Midway City Council 3 August 2021 Regular Meeting

The Reserve at Midway, Phase 1 / Plat Map Amendment

CITY COUNCIL MEETING STAFF REPORT

Plat Amendment

Exhibit 2

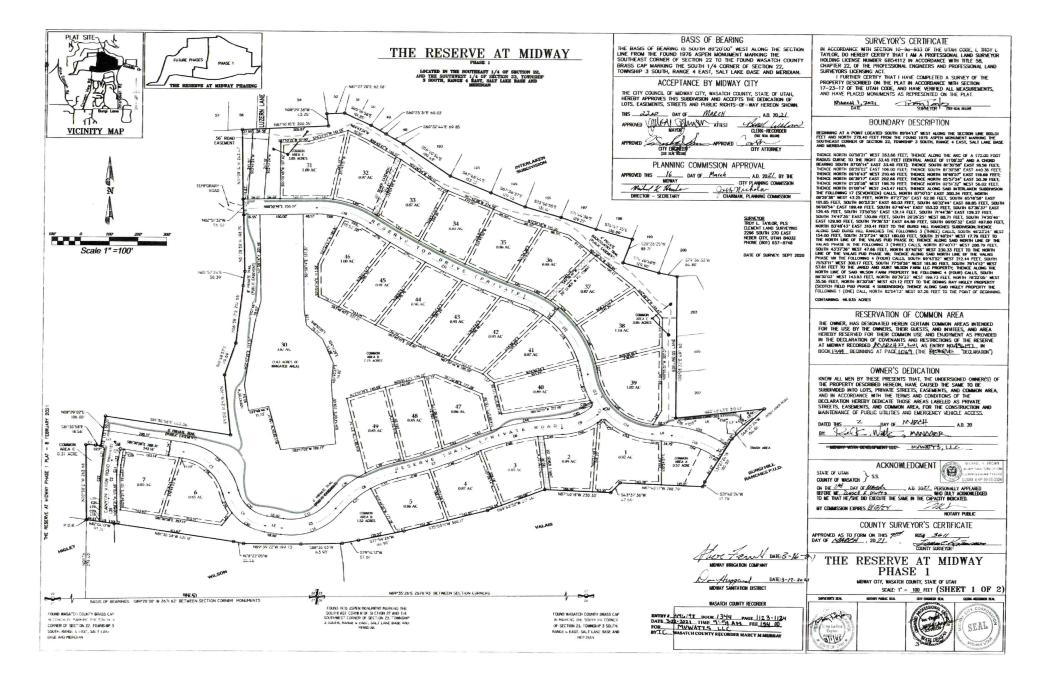
MVWATTS LLC is proposing a plat amendment to The Reserve at Midway Phase 1 to change the names of the two main roads. Reserve Top Drive will change to Altamont Drive and Reserve Trail will change to Hampton Drive. Both roads and private with public access easements. The proposed adjustment will require all addresses on the plat to be adjusted to reflect the new road names. No other adjustments to the plat are being proposed at this time.

1	1B2 EAST ALTAMONT DRIVE
2	148 EAST HAMPTON DRIVE
3	134 EAST HAMPTON DRIVE
4	118 EAST HAMPTON DRIVE
5	98 EAST HAMPTON DRIVE
6	34 EAST HAMPTON DRIVE
7	14 EAST HAMPTON DRIVE
30	8 EAST ALTAMONT DRIVE
31	19 EAST ALTAMONT DRIVE
32	37 EAST ALTAMONT DRIVE
33	53 EAST ALTAMONT DRIVE
34	73 EAST ALTAMONT DRIVE
35	89 EAST ALTAMONT DRIVE
36	105 EAST ALTAMONT DRIVE
37	121 EAST ALTAMONT DRIVE
38	135 EAST ALTAMONT DRIVE
39	169 EAST ALTAMONT DRIVE
40	146 EAST ALTAMONT DRIVE
41	128 EAST ALTAMONT DRIVE
42	108 EAST ALTAMONT DRIVE
43	92 EAST ALTAMONT DRIVE
44	78 EAST ALTAMONT DRIVE
45	62 EAST ALTAMONT DRIVE
46	48 EAST ALTAMONT DRIVE
47	119 EAST HAMPTON DRIVE
48	107 EAST HAMPTON DRIVE
49	93 EAST HAMPTON DRIVE

PLAT AMENDMENT NOTES: RESERVE TOP DRIVE HAS BEEN RENAMED ALTAMONT DRIVE
